Hinckley & Bosworth Borough Council

Response to Secretary of State:

**Application by Tritax Symmetry
(Hinckley) Limited for an Order Granting
Development Consent for the Hinckley
National Rail Freight Interchange**

(ref. TR050007)

Figure 2.1: Light Vehicles Trip Distribution to and from the Hinckley NRFI Development Site
2026 'With Development' (AM) - To the Development

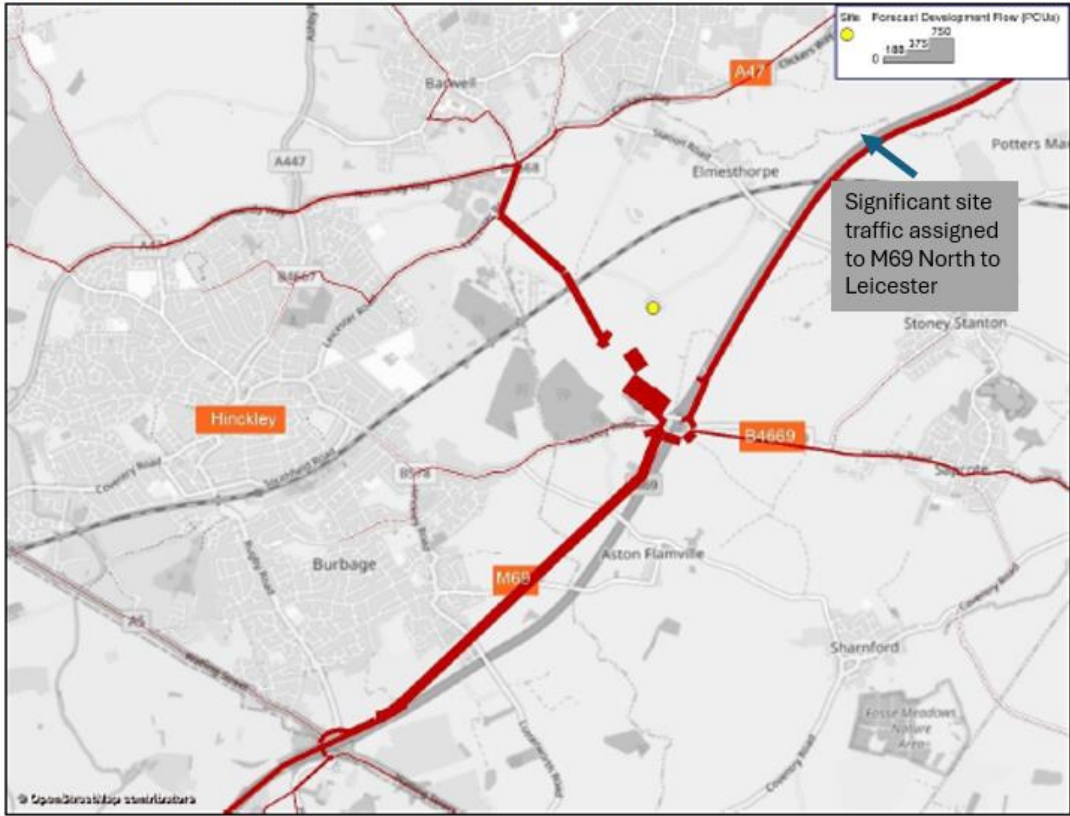
Figure 2.1 of this report shows the distribution of traffic to the development in the am peak in 2026, clearly showing very high volumes of development traffic wishing to use the M69 from Leicester to the site (the corresponding figure for traffic travelling from the development shows a similar picture heading away to the north).

Figure 3.6: Forecast Flow Change for the 2026 and 2036 'With Development'

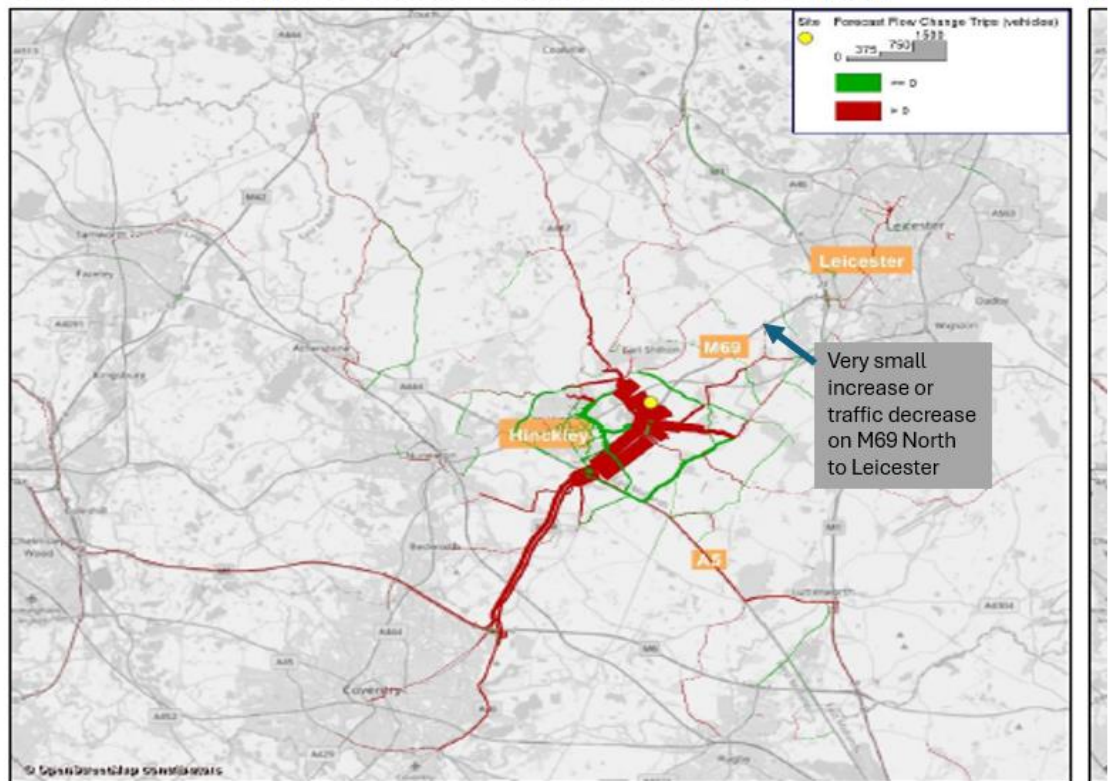
3.9. However Figure 3.6 shows the actual modelled traffic – there is a very small increase in one direction and a decrease in traffic on the M69 north post-development. This is because of the conditions at J21 and the Applicant's additional traffic: in effect every single vehicle added by the development pushes off the M69 an existing vehicle to less suitable local roads. This outcome is almost entirely due to the congestion at J21 of the M1. It is for this reason that HBBC (and LCC) are insistent on the correct modelling of this junction so that the impact and knock-on impact and appropriate mitigation can be properly understood.

Figure 1: M1 NB block back

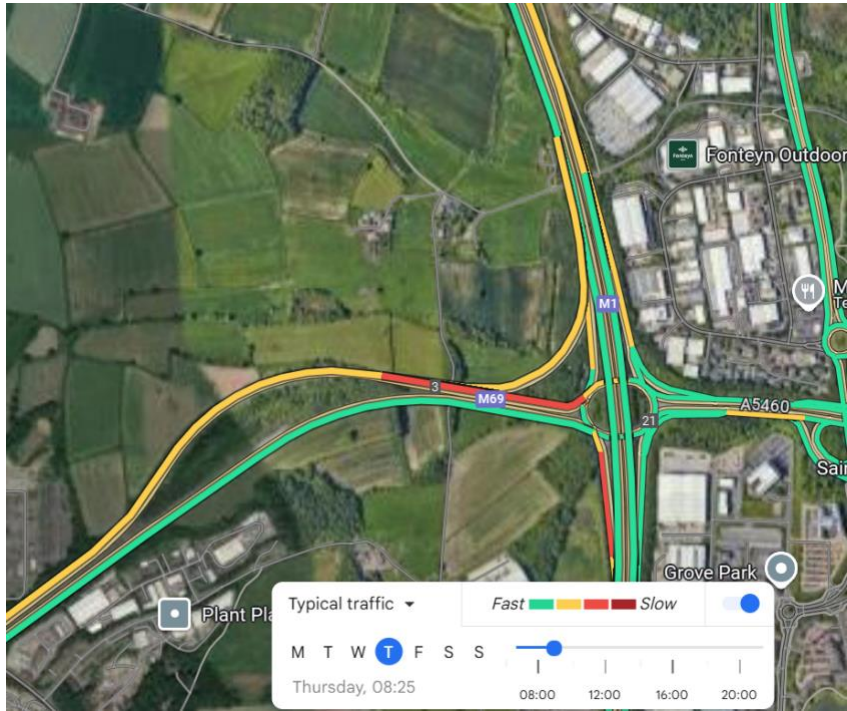
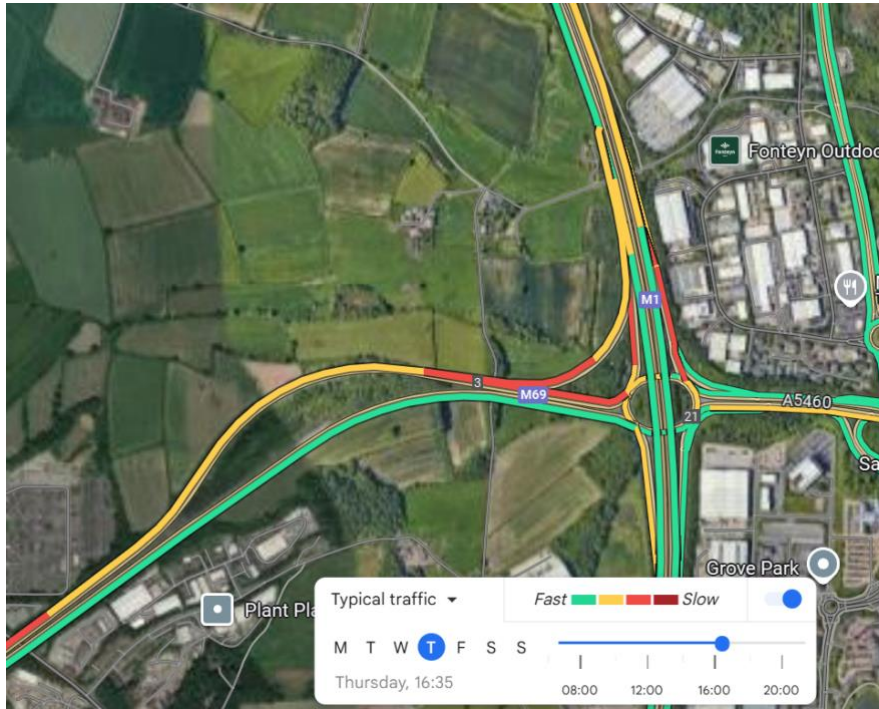
- 3.11. HBBC fully supports the latest LCC and National Highways view that the modelling submitted by the applicant for J21 is not fit for purpose - consequently it cannot be relied upon to determine the impact of the development on the strategic and local networks and on road safety. As set out clearly by LCC and NH, the ‘LinSig’ does not adequately model the complex interactions between traffic streams here and the level of congestion. Congestion is referenced by the Applicant in the modelling report HNRFI-BWB-GEN-XX-RP-TR-000X M1 J21 Modelling Output Audit and is shown in Figure 1 of that report:
